PD Modification Application: MM 24-0034

Zoning Hearing Master Date: July 22, 2024

Proposed MM 24-0034: The proposed Major Modification requests to amend the conditions of approval for PD 92-0366, that has had no subsequent amendments in the intervening +/- 32 years since its 1992 adoption. The applicant proposes an Option #2 to allow up to 136,000 square feet of non-residential uses including Office and Retail uses fronting SR 674, with a Mini-Warehouse building located in the northeast quadrant of the site.

Case Reviewer: Tim Lampkin, AICP

2.5 Proposed Site Plan (partial provided below for size and orientation purposes. See Section 8.2 for full site plan)

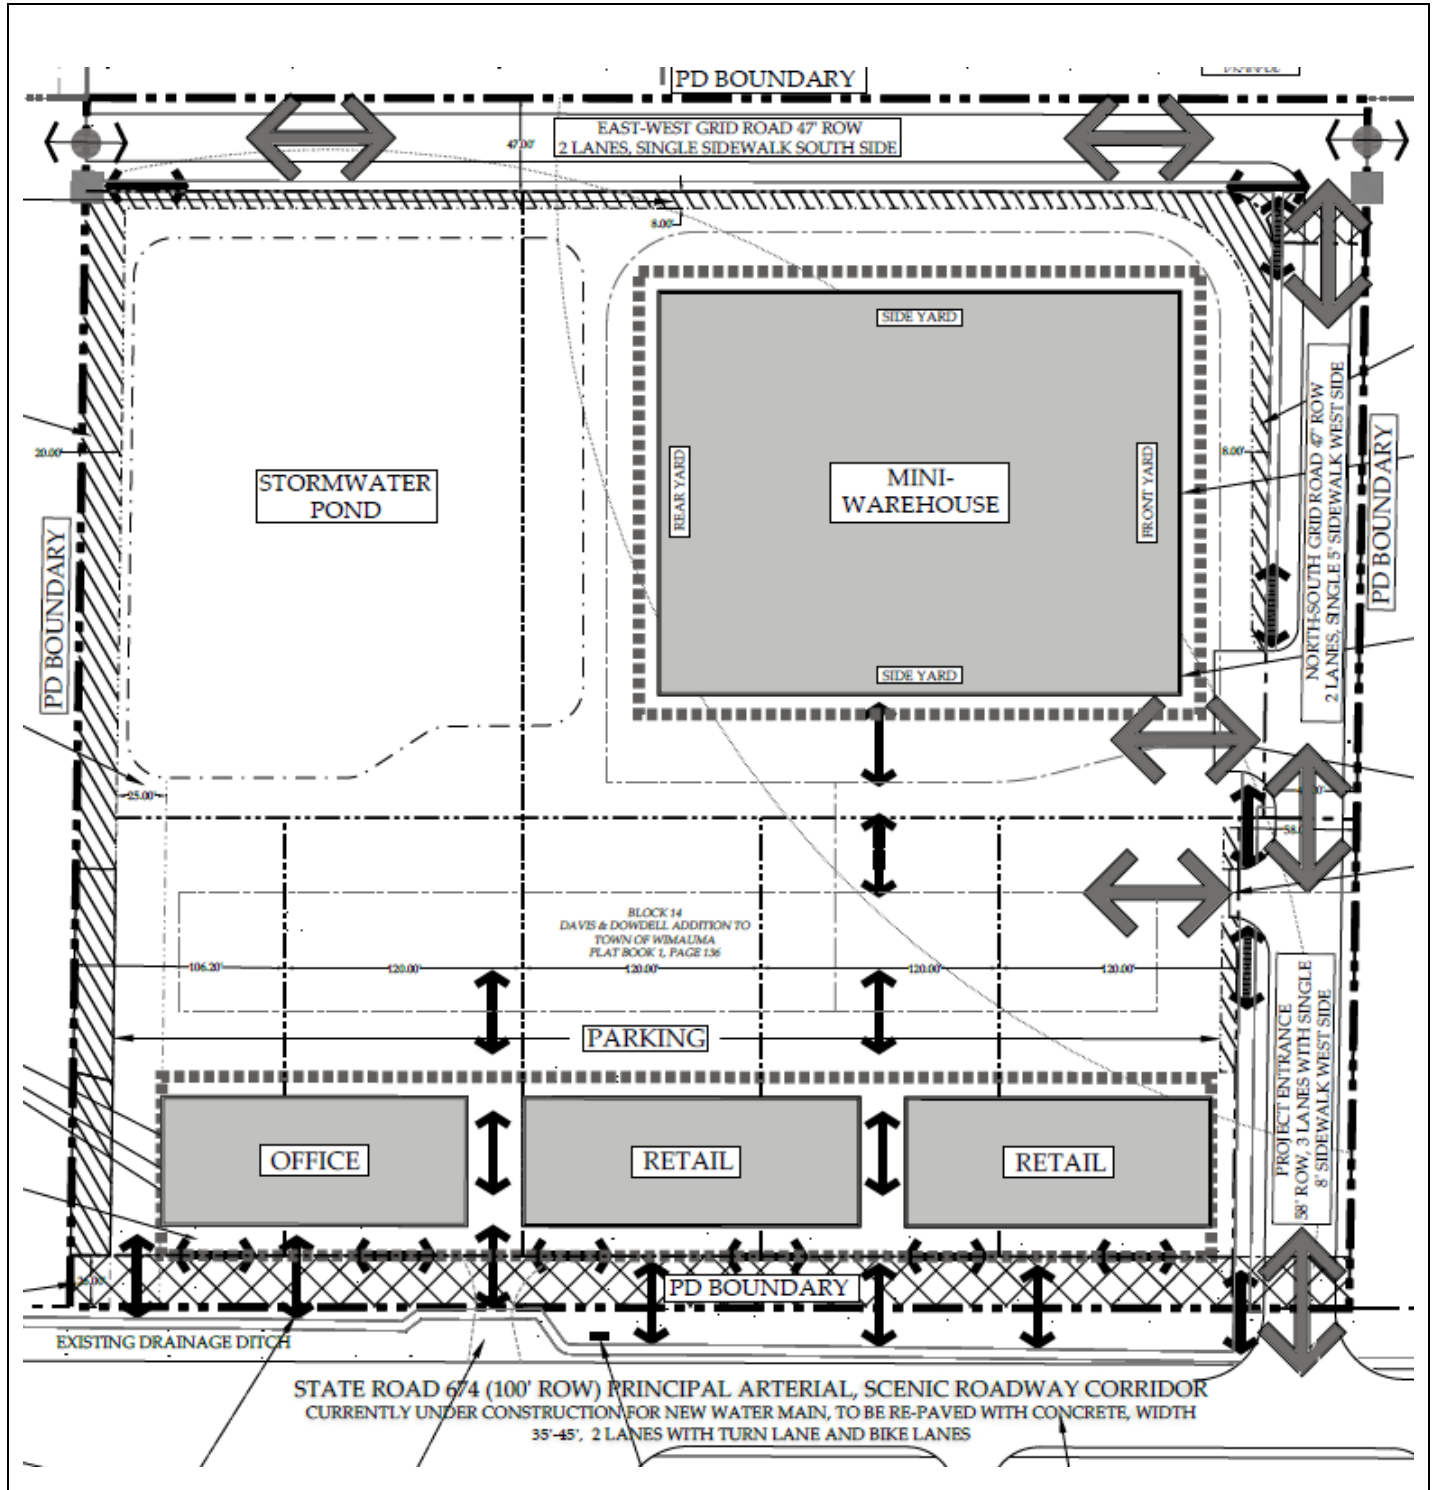
- Remove “All Existing Improvements and Lot Lines to be Removed and Re-configured” on Option 1 Site Plan.
- Remove “Existing Driveway to be Closed and Relocated” on Option 1 Site Plan.

- Revise “PD PRS PD 92-0366” to “PD 92-0366”
- The blank box to the left of the notes previously had the Legend. Re-insert the Legend text in the box.
- Modify site note # 13. as follows: “EXISTING AND PROPOSED POINTS OF INGRESS AND EGRESS: ONE EXISTING POINT OF ACCESS ON SR 674 SHALL BE CLOSED, AND A NEW DRIVEWAY SERVING THE PROJECT SHALL BE CONSTRUCTED. THE PROJECT ACCESS ON SR 674 IS SUBJECT TO FDOT APPROVAL.”

- Modify site note # 16, as follows: “INTERNAL CIRCULATION AND PRIVATE DRIVES: INTERNAL ACCESS SHALL BE PROVIDED WITH PRIVATE DRIVE AISLES WITH THE EXCEPTION OF THE PROPOSED NORTH-SOUTH ROAD AND EAST-WEST ROAD SEGMENTS AND SURFACE PARKING BUILT TO HILLSBOROUGH COUNTY PARKING AND LOADING STANDARDS. THE MINI-WAREHOUSE USE MAY BE GATED.”

- Modify site note # 17, “RIGHT-OF-WAY RESERVATION/DEDICATION: AREAS OF RIGHT-OF-WAY (ROW) RESERVATION ARE SHOWN ON THIS PLAN TO ALLOW FOR THE FUTURE WIDENING OF SR 674 TO 126' ROW. ADDITIONAL ROW DEDICATION PROPOSED FOR THE PROJECT ENTRANCE AT 58', AND THE NORTH-SOUTH AND EAST-WEST GRID ROADS AT 47', A SHOWN.”

- Add a double headed arrow on the eastern boundary with a label that states “The adjacent property may take access to the roadway subject to County Standards and Requirements.”

- Re-insert the “East-West Grid Road View East” and “Project Entrance View North” into the box in the lower SW quadrant labelled “Proposed Roadway Cross Sections”

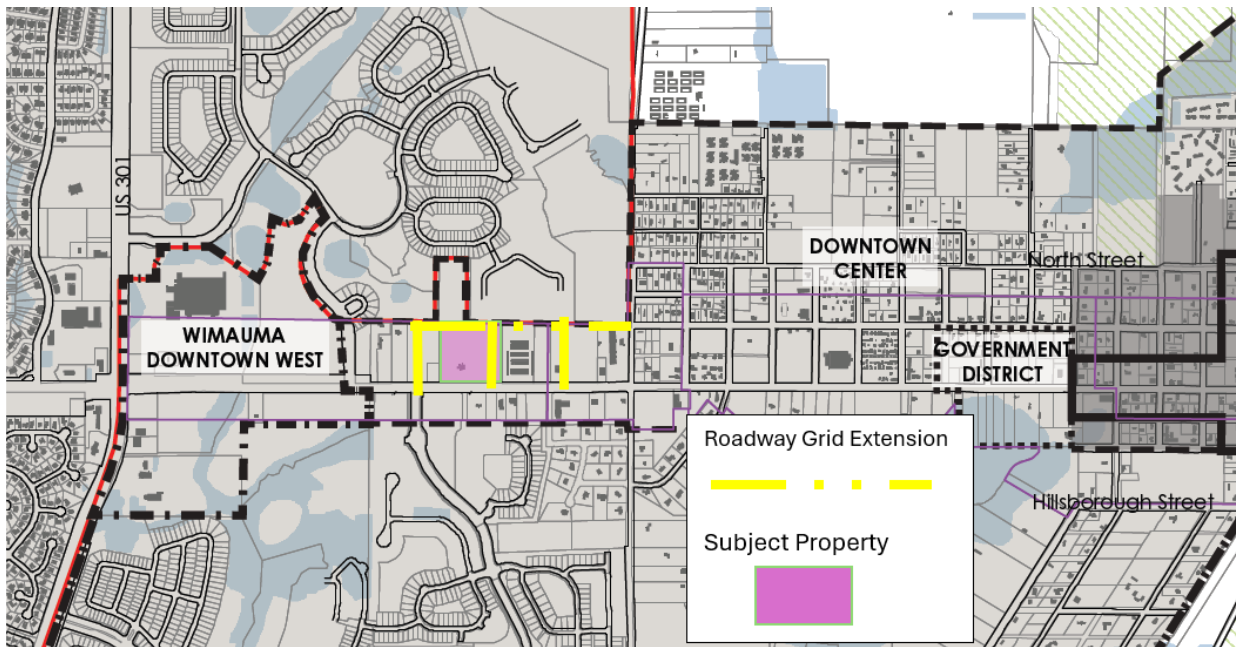
SR 674 is shown on the Hillsborough County Corridor Preservation Plan as a future 4-lane facility. According to FDOT staff, a PD&E (SR 674 Widening from US 301 to CR 579/ Project#: 422762-1) was

conducted for the area which identified 126 feet of right-of-way needed to accommodate the future 4-lane facility. The proposed PD site plan proposes 26 feet of preservation along the project's frontage.

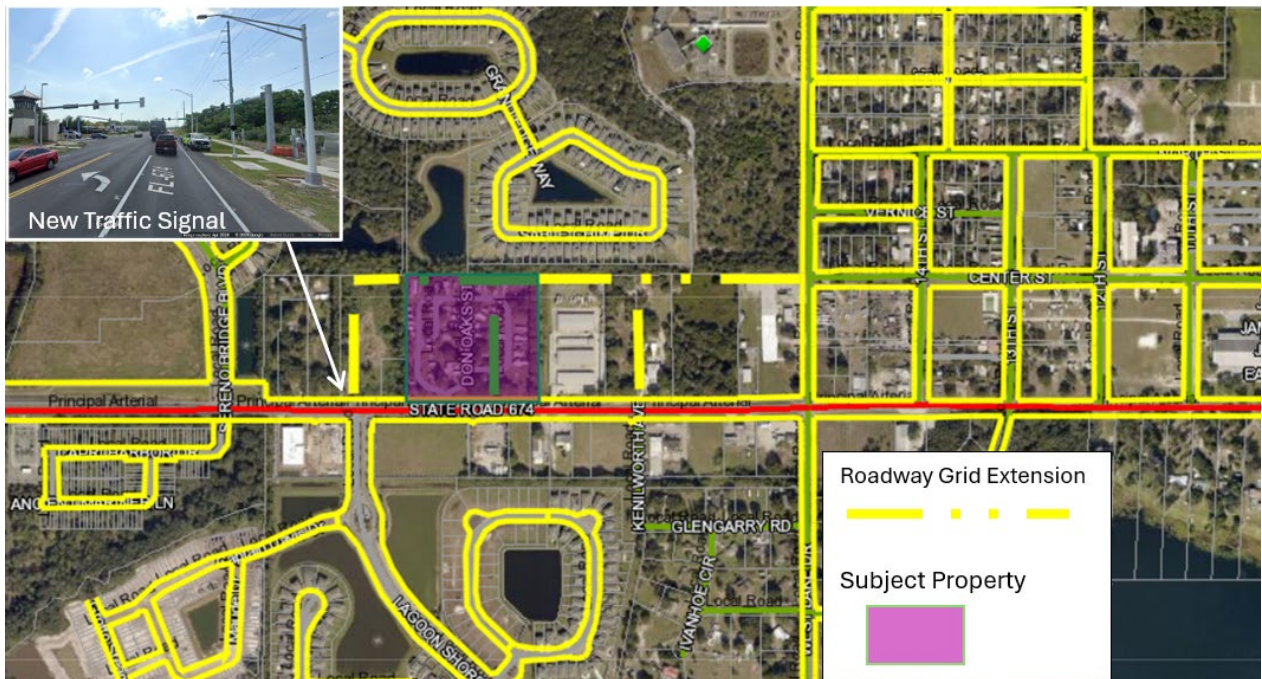
The projects proposed internal grid roads are consistent with the above cited Downtown Wimauma standards. The proposed public local roadways are designed as the project access to SR 674 and located along the eastern and northern boundary of the subject property to provide access to the adjacent properties also within the Wimauma Downtown District to the east and to the west at the time that they redevelop.

The proposed internal grid roads will also fulfill the Sec. 6.04.03.Q. cross access requirements and the special connectivity requirements of the Wimauma Downtown Overlay District, Section 3.23.10.C.1. Additionally, the north-south grid road/access connection to SR 674 will enable the adjacent parcel to the east (folio# 78891.000) to take access directly to it. This will permit FDOT the option of closing the access to the adjacent property upon its future development/redevelopment, in which case it would utilize the proposed new grid roadway within the subject PD. Such configuration will improve spacing compliance and enhance safety within the corridor in the future. See the annotated screenshot from the County GIS viewer below demonstrating the conceptual connectivity of the future grid network aligning with the existing Center St. roadway to the east and the recently signalized intersection of Lagoon Shore Blvd. and SR 674.

Required Public Transit Facilities

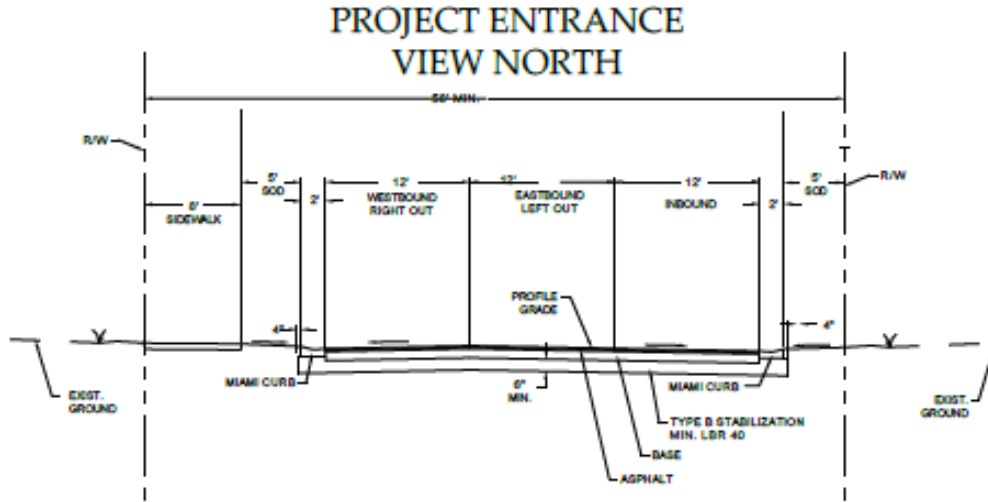
As required by Sec. 6.03.09.C.3. of the LDC, the developer shall construct a transit accessory pad and bus shelter, which shall include seating, a trash receptacle and bicycle rack in accordance with Hillsborough Area Regional Transit (HART) design standards. Notwithstanding anything herein these conditions or on the PD site plan to the contrary, the final location of the facility will be determined at the time of plat/site/construction plan review and is subject to approval of Hillsborough County and HART.

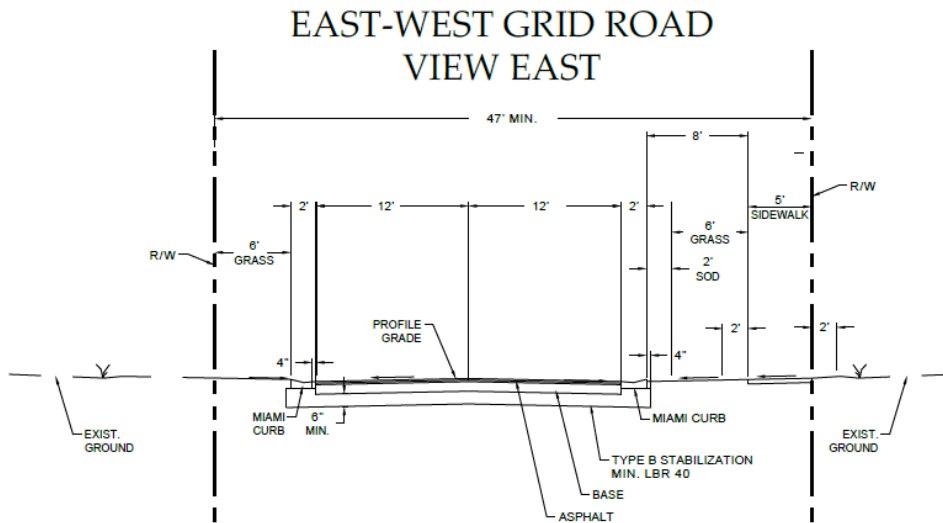
The remaining section of the North-South roadway consists of two 12-foot lanes and a 5-foot sidewalk on the westside within a total 47 feet of right of way. This segment will intersect with the proposed East-West roadway.

The East-West roadway will provide connectivity between the North-South roadway and the future extension of the grid to the east and west upon redevelopment of the adjacent properties, who will be responsible for constructing their respective segments. The section consists of two 12-foot lanes and a 5-foot sidewalk within 47 feet of right of way. See proposed section below.
